Upper Trishuli-1 HEP (216MW)

REVIEW NOTE

Contractor	**Doosan Enerbility**		
Title of the Document	Detail Design Drawing of Excavation and Support for Underground Cavern & Design Change Notification		
Document No.	UT1-C-000-CVL-DG-40001	Revision	3A
Date of Documents	11.07.2023	Received Date	11.07.2023
Transmittal Form No.	UT1-HEP-DHI-D-0880		
Previous Review Date/Status	07.06.2023/FC	Prev. Review Note No.	N/A
Review Note No.	**RN-0731**	**Present Review Date**	**14.07.2023**
		Present Review Status	**RR**

DOOSAN	Design Change Notice	DCN No. DCN-23-C-007
	UPPER TRISHULI-1 HEP (216MW)	GRADE : A
		PAGE: 1 OF 2

Rev. 3A

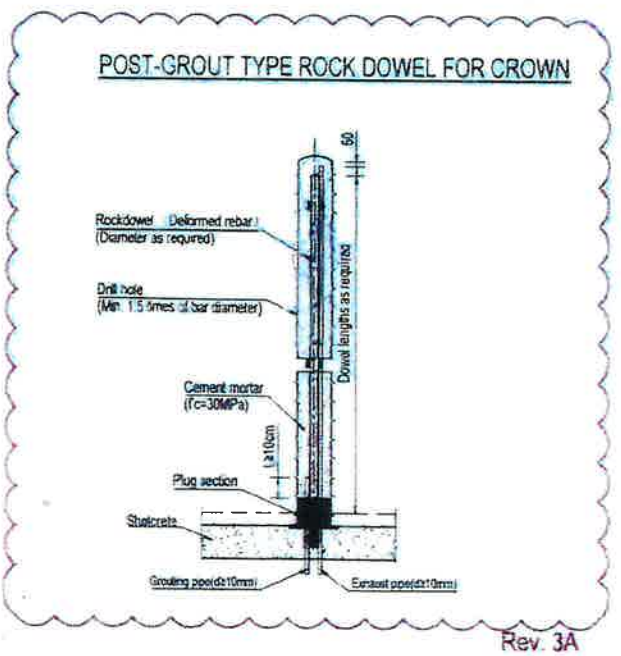
The drawings were changed according to the specifications to make the site construction more clear. For details as follows:

UT-1 HEP Annex 13 Part C, Chapter 13.2.2D.

> D. The groutable bolt assemblies shall be provided with positive means of sealing the hole at the bearing plate, and grouting at the lowest elevation of the hole whole expelling air at the highest elevation of the hole.

Post-grout rock dowel support is added accordingly in revised drawing. For reference, the figure is mentioned below. The grouting procedure for Rock dowel installation is as follows:

① Drill the desire length of a bore hole.

② Fix the dowel into a hole with inlet injection the pipe and outlet vent pipe.

③ Plugging section length shall be 0.2m to 0.3m and also it can be adjusted according to the length of the rock dowel.

④ The final grout of the dowel the following day. Until out flow from the vent pipe to assure the hole full of grout.

⑤ Pull out the test after 28 days as per specification.

DCN-23-C-007 rejected due to the following reasons;

1. The proposed rock dowels cannot be approved as they were proven unreliable by the failure of the powerhouse roof.
2. The reason for the failure of such support were proven manifold. This is well known to the employers, PQE's and the contractor.
3. The experience made in the UT1 project does not allow an approval of potentially unreliable support for all underground works.
